<b>SERVICE LETTER NUMBER 154</b>			
<b>TITLE: MAIN GEAR OLEO AND TOP ARM REPLACEMENT</b>			
BY: J. SORTOR	AIRCRAFT MAKE/MODEL(S):	FLOAT MODEL(S):	NOTE(S):
APP: C. WOKEN	CESSNA 208	WIPLINE MODEL 8750	MANDATORY COMPLIANCE
DATE: 6/24/14	CESSNA 208B	WIPLINE MODEL 7000	ECO—23673
REV: C	QUEST KODIAK 100		S/L P/N 1006963

**FAA APPROVAL HAS BEEN OBTAINED FOR TECHNICAL DATA IN THIS PUBLICATION THAT AFFECTS STC OR TSO DESIGN COMPLIANCE**

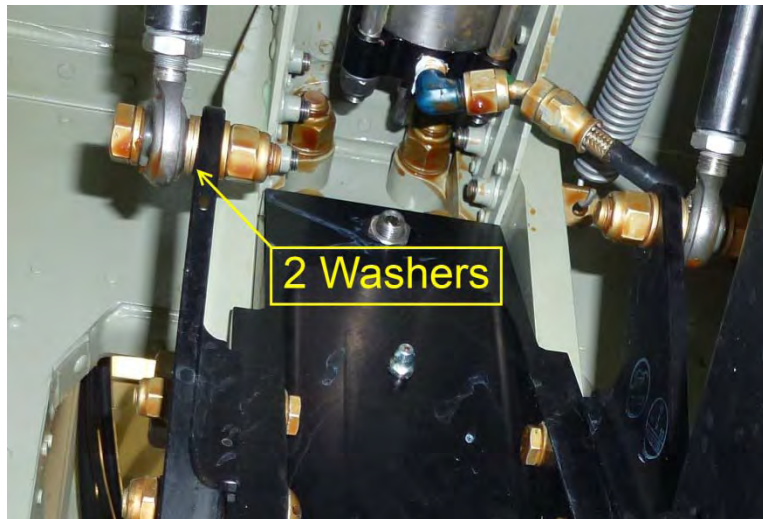
1. Place aircraft on jack stands.
2. Pull the circuit breakers for the landing gear hydraulic pumps.
3. Remove the AN12 bolts (**1**) at the top and bottom of the oleo-pneumatic shock strut and remove the oleo shock strut from the float.
4. Unbolt the tie rod ends (**2**) where the two Linkage Rods attach to the Top Arm Brackets.
5. Remove the AN12 bolt (**3**) that attaches the Main Gear Top Arm Assembly to the Main Gear Top Mount.

6. Remove the left and right Top Arm Brackets (**4**) P/N 1004927 and 1004928 from the old Main Gear Top Arm Assembly and install them on the new top arm assembly P/N 1006860. Install the Top Arm Brackets and safety-wire the hardware following the instructions from Wipaire Service Kit 76. Use corrosion preventative grease on hardware and mating surfaces. Note that match drilling of holes per Service Kit 76 will not be necessary as the replacement Top Arm (P/N 1006860) has all the required holes. Standard torque specifications found in AC 43.13 Table 7-1 are used for the hardware attaching the Top Arm Brackets to the Main Gear Top Arm Assembly.

- Place the included trim template (5) P/N 1006964 onto the center of the Horizontal Stiffener on Bulkhead #10. The stiffening angle runs horizontally across the aft face of the step bulkhead right below the cutout box that the oleo shock tucks up into when the landing gear is retracted. The trim template needs to be centered along the length of the angle and will nest over the heads of the AN470-4 rivets. The material not covered up by the trim template will be removed to provide 3/16" of additional clearance for the oleo shock strut when the landing gear is being extended and retracted. Scribe along the trim template to mark section of the angle to be removed.

8. Trim the horizontal angle up to the marked line using a high-speed grinder and burr bit. Smooth the cut and touch up the finish using an alodine pen and either a zinc-chromate primer or epoxy based primer.

9. Install the new top arm assembly P/N 1006860 with the attached Bracket Arms from Step 6 using the AN12 bolt and hardware removed in Step 5. When tightening the AN12 bolt, gently snug the nut and then back off approximately 1/8 turn allowing for free rotation of the Top Arm. Make sure that the Gear Down Adjustment Setscrew (6) is not protruding past the flat forward face of the Top Arm Assembly at this time. If the adjustment setscrew is protruding (toward the position sensor switch), loosen the setscrew jam nut and back out the setscrew to recess it into the top arm. A protruding adjustment setscrew that contacts the down position proximity switch could damage the proximity switch. The setscrew will be adjusted for the proper location in Step 16.
